5774 SALT ROAD LLC
SALT ROAD
TOWN OF CLARENCE - ERIE COUNTY - NEW YORK
PRELIMINARY DRAINAGE / GRADING PLAN

To: Jonathan Bleuer, Director of Community Development
From: Joseph Lancellotti, Asst. Municipal Engineer 
CC: Wm Schutt Associates, 37 Central Ave, Lancaster, NY 14086
5774 Salt Road, LLC, 9410 Martin Road, Clarence Center, NY 14032
Timothy Lavocat, P.E., Town Engineer
File
Date: January 30, 2025
Re: 5774 Salt Road Private Subdivision- Preliminary Grading and Drainage Plan

The Engineering Department has reviewed the Preliminary Grading and Drainage Plans dated January 14, 2025 and received on January 22, 2025. This concept level review is not an all-inclusive project review and additional comments may be warranted and provided at any time throughout the formal project review process. The below comments are to be addressed during the Development Plan review process.

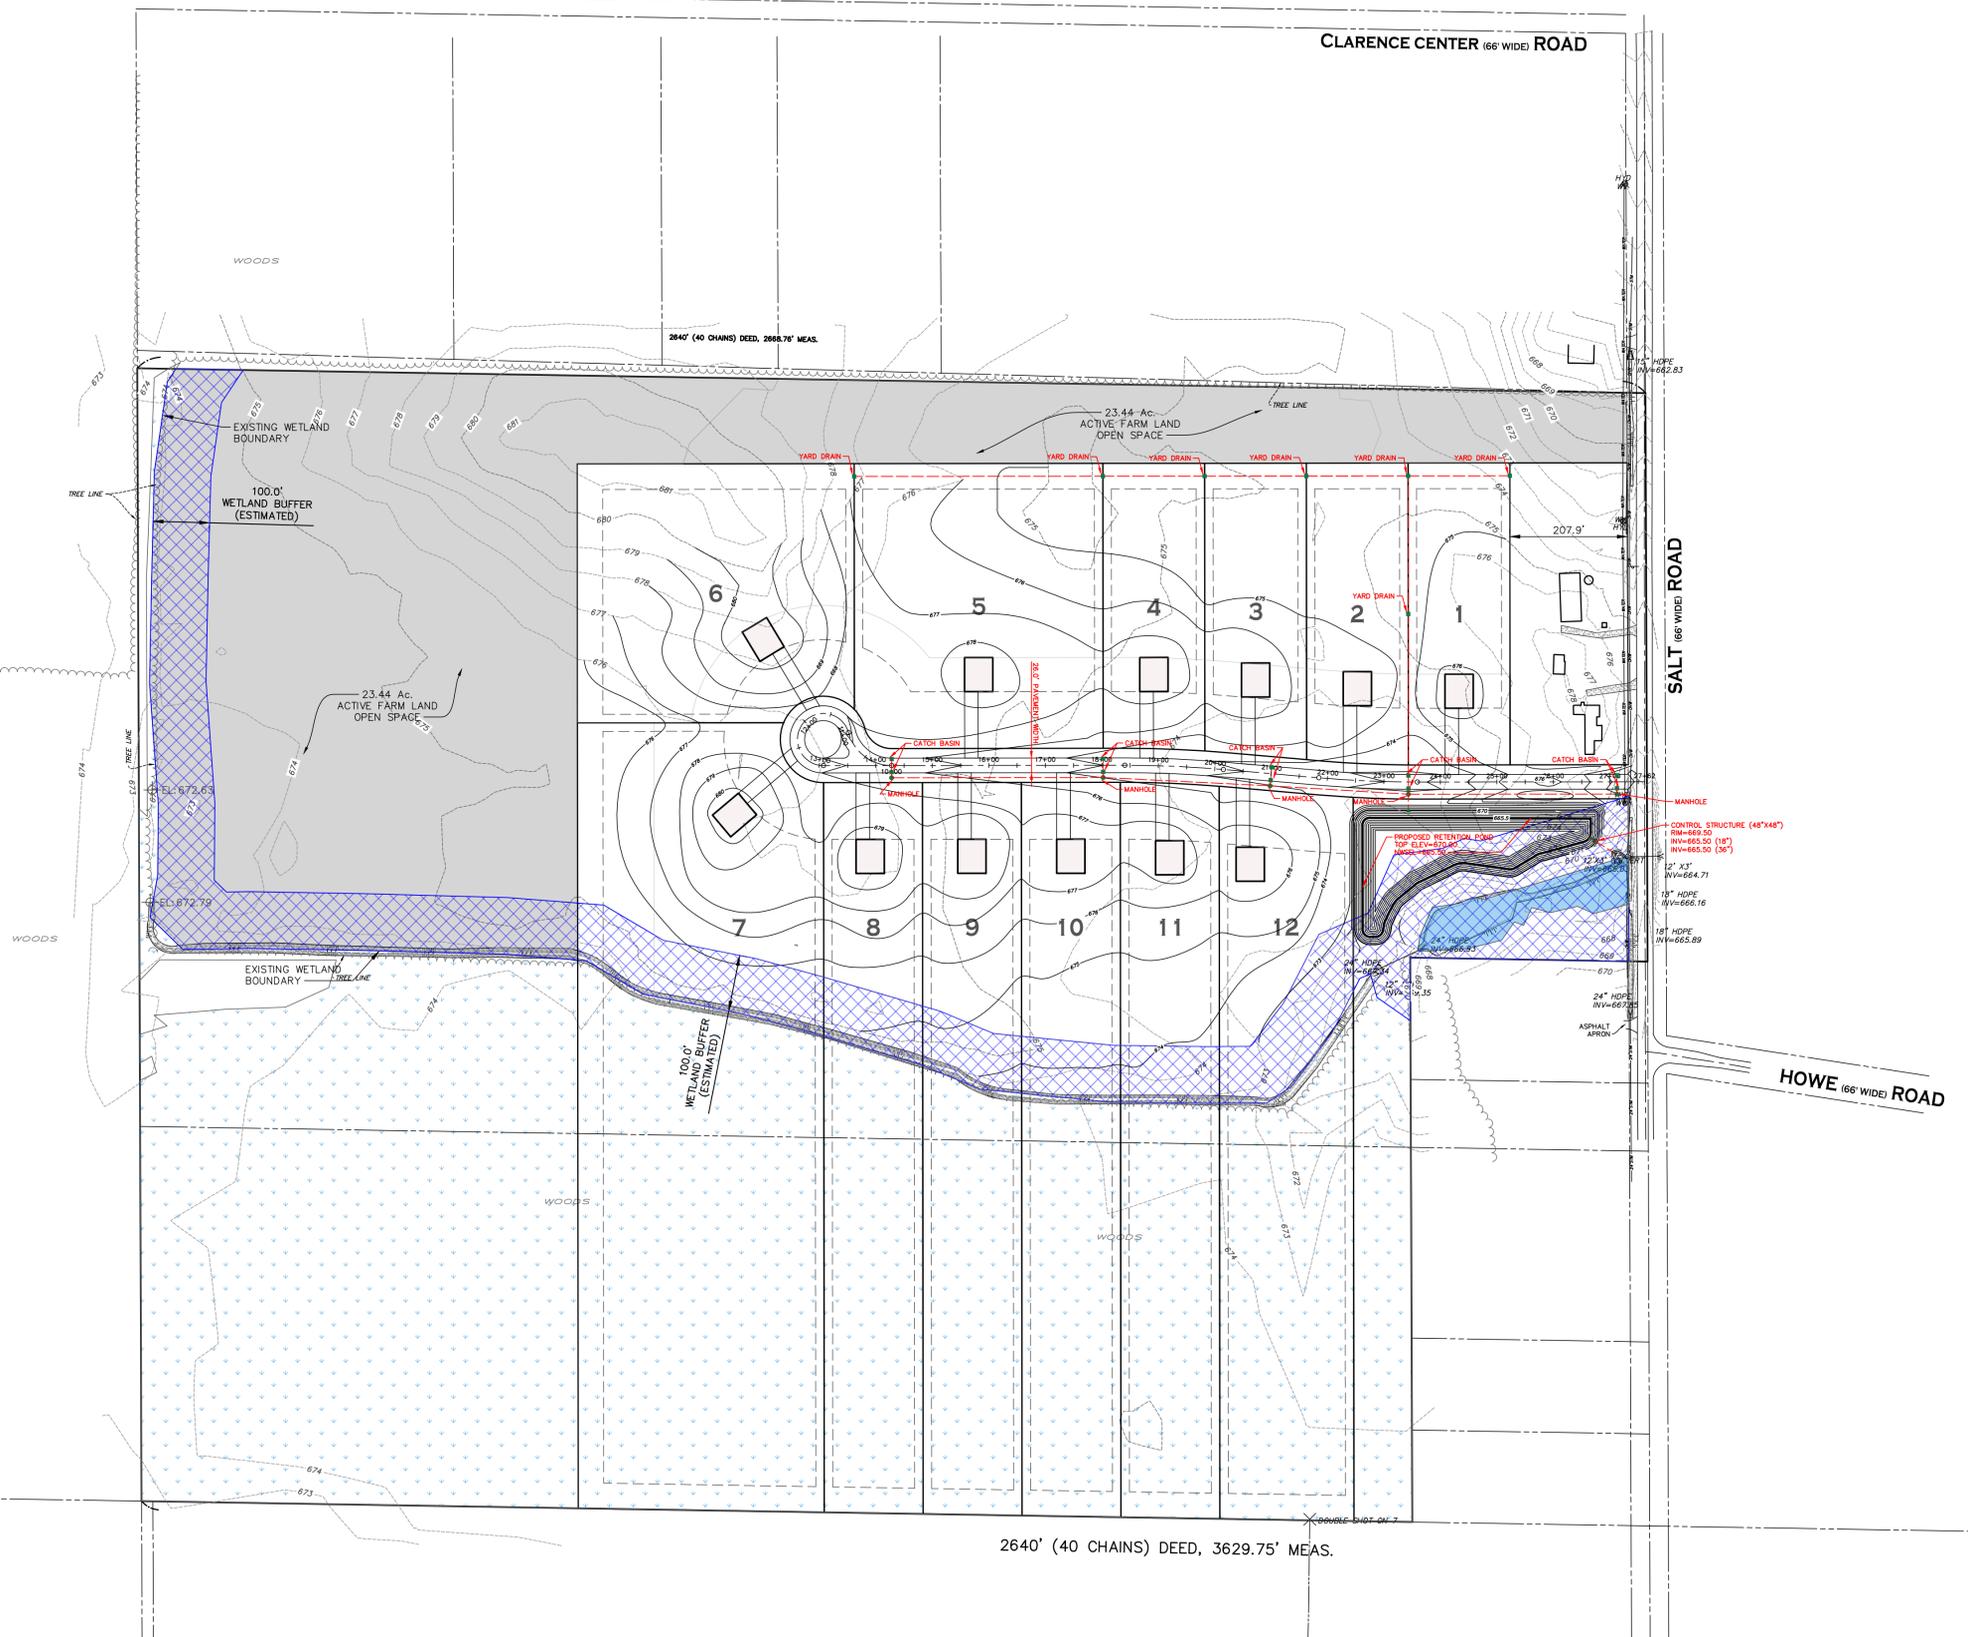
1. Provide a rear yard drainage solution between lots 6 and 7. The need for additional rear yard drainage will be reviewed for lots 7-12 based on stream depth and capacity.

2. Include the pond forebay on the plans in accordance with the stated narrative in the report.
3. Vehicular protection near the proposed pond will be reviewed during the Development Plan process.

10. A hydrogeologic/geotechnical evaluation is required for deep excavations. Please provide a soil bore to refusal and associated hydrogeologic/geotechnical evaluation report for the proposed pond. Soil bores are to be within excavation footprint. The report is to include, but not be limited to analysis of the deep soils, soil stability, proximity to existing structures, basin constructability, groundwater, dewatering operations, ability to hold water, etc. The Engineer's Report is to be stamped and signed by a hydrogeologic or geotechnical engineer licensed by the State of New York.

TITLE:
OVERALL SITE & TRAFFIC CONTROL PLAN

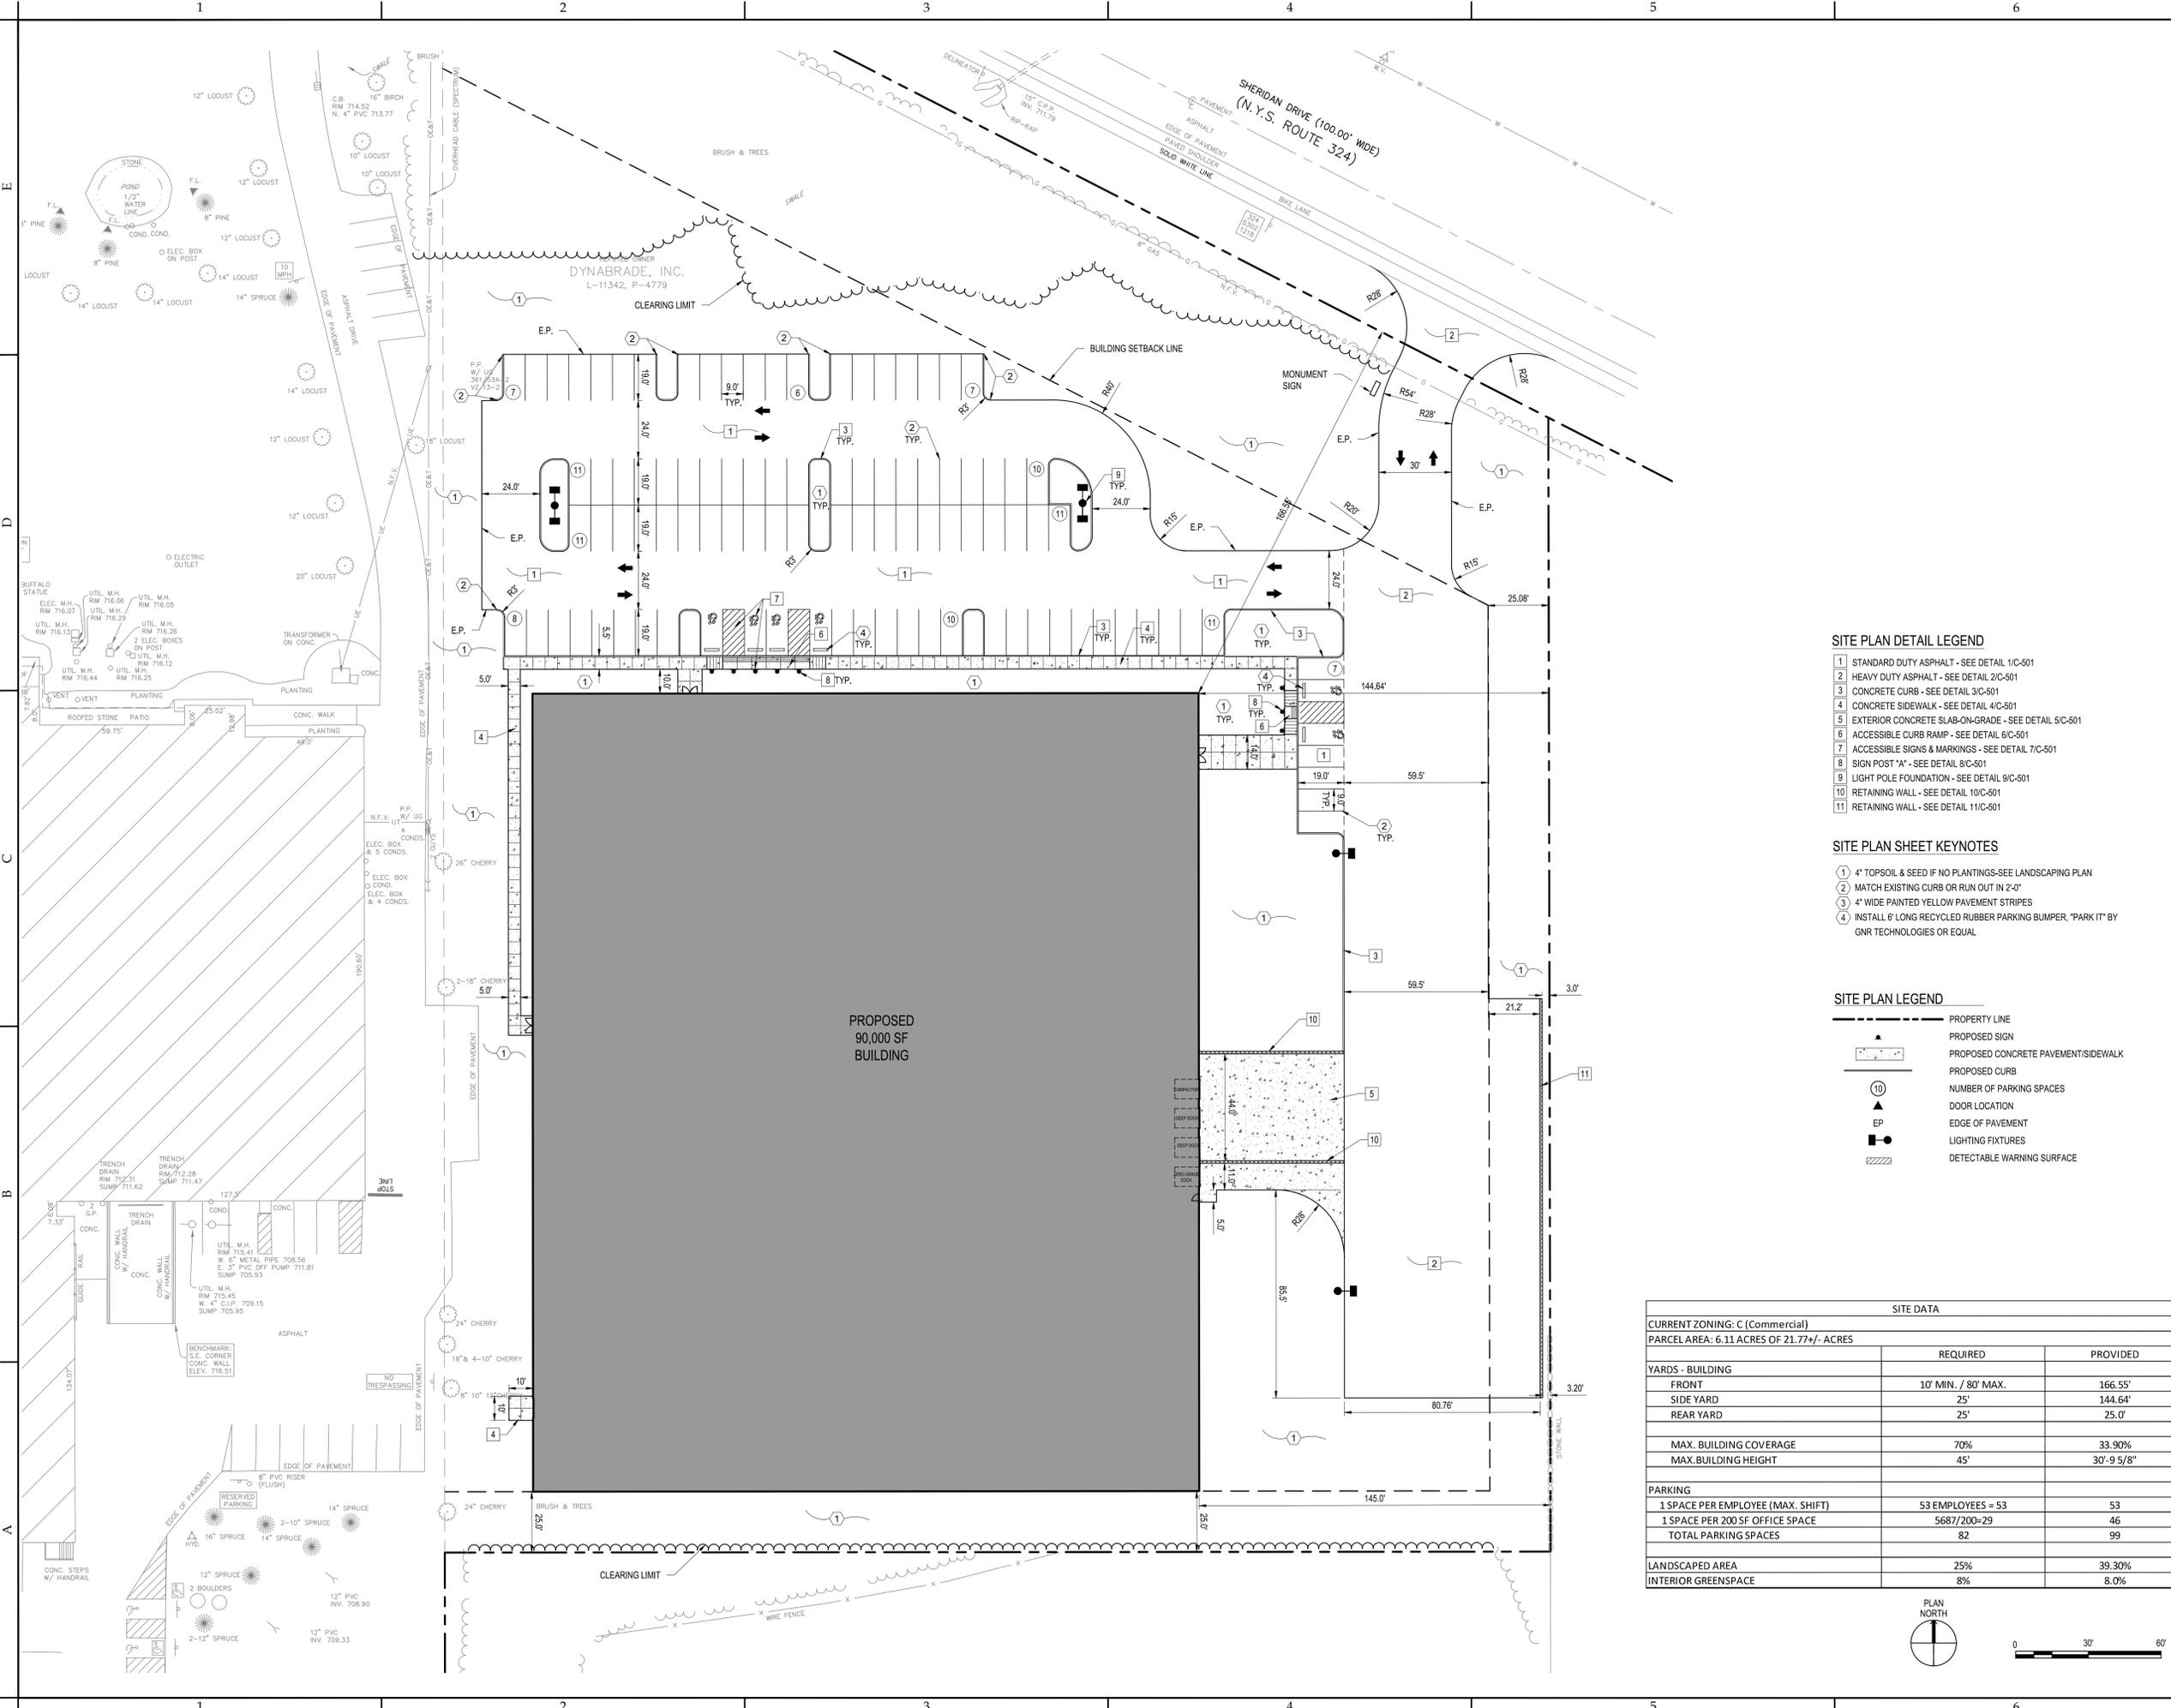
Comment #2: NYSDOT does not intend to allow the new driveway onto Sheridan Drive as proposed. A solution may be to mirror the proposed building on the N/S axis to locate the new shipping/receiving area adjacent to and accessible by the current central driveway of the site.

Response to Comment #2: Subsequent to this comment letter, further correspondence took place between the design team (Dynabrade and C&S Engineers) along with the NYSDOT and NYS Senator Gallivan's office to come to a solution to this comment. Attached please find the correspondence email from the NYSDOT allowing the third curb cut with the condition of removing the project's connection points to the central access drive. Please note that the connection points from the project project to the central access drive have been removed on the attached, revised plans.
